BULLETIN # 1 1

PROJECT: Harrison Recreation & Community Center – PHASE 1
Harrison, NY

RE: Additional underground conduit for Phase 2 lighting fixtures

ASK-07 ADDED PHASE 2 LIGHTING CONDUIT
2024-04-09

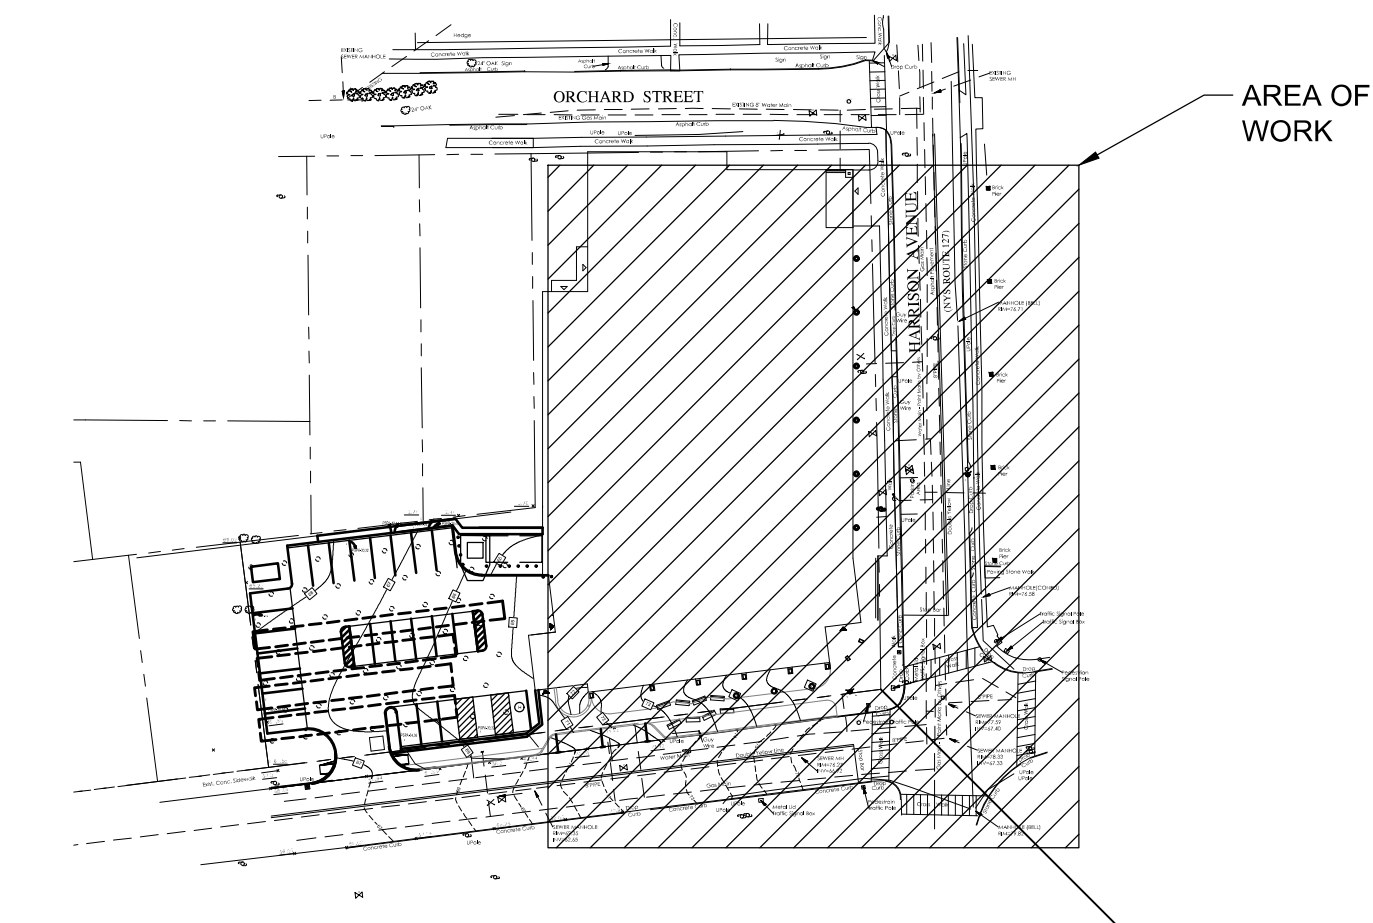
Please provide pricing for the addition of conduit and junction boxes as shown on ASK-07 which references Sheet E-011 from the Phase 2 set. East side conduit to stub through foundation wall. The south side conduit to extend to the Electrical Room. Conduit type per the schedule on ASK-07.
